[Docket No. FAA-2007-28661; Directorate Identifier 2007-NM-013-AD; Amendment 39-16785; AD 2011-18-03]

#### Airworthiness Directives; The Boeing Company Model 737-600, -700, -700C, -800, and -900 Series Airplanes

**ACTION:** Final rule.

Figure 1

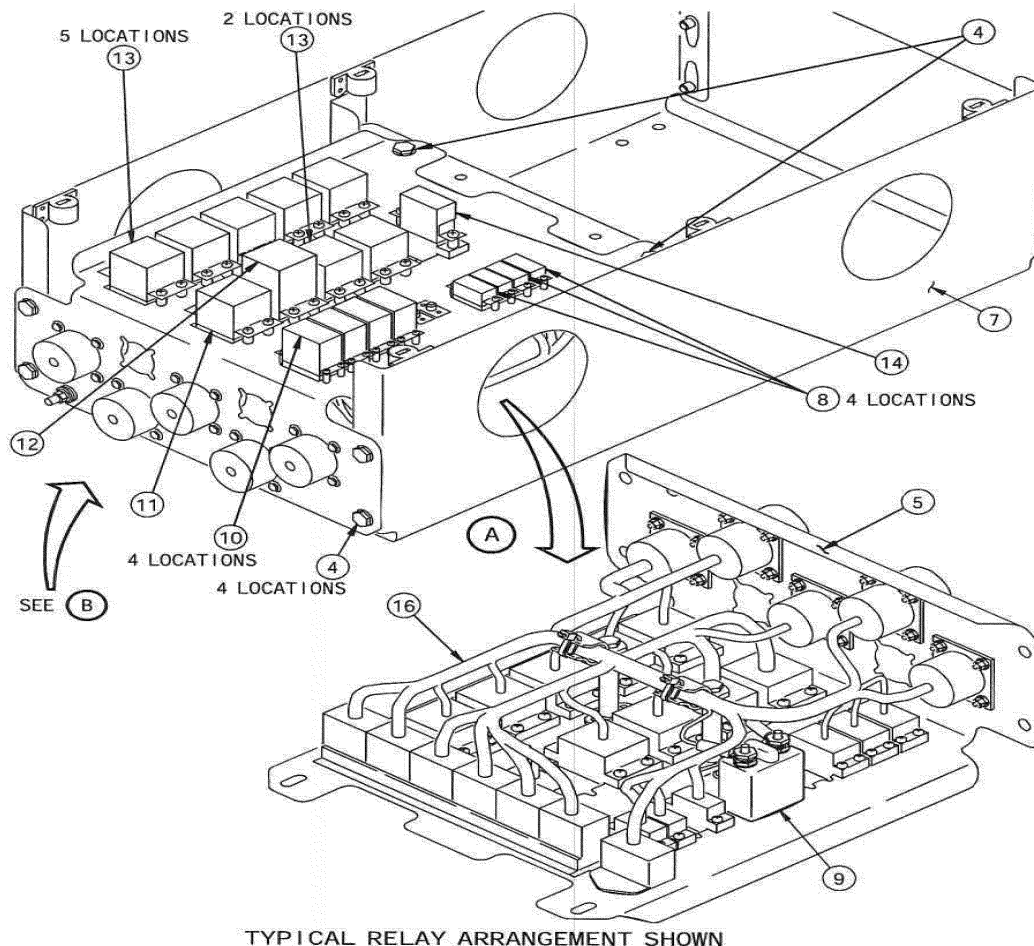
Part 1 and Part 2 of the Accomplishment Instructions of Boeing Alert Service Bulletin 737-28A1206, Revision 2, dated May 21, 2009, except that Figure 1 of this AD must be used in lieu of Sheet 2 of Figure 11 of Boeing Alert Service Bulletin 737-28A1206, Revision 2, dated May 21, 2009. If a placard has been previously installed on the airplane in accordance with paragraph (h) of this AD, the placard may be removed from the flight deck of only that airplane after the automatic shutoff system has been installed. Installing automatic shutoff systems on all airplanes in an operator's fleet, in accordance with this
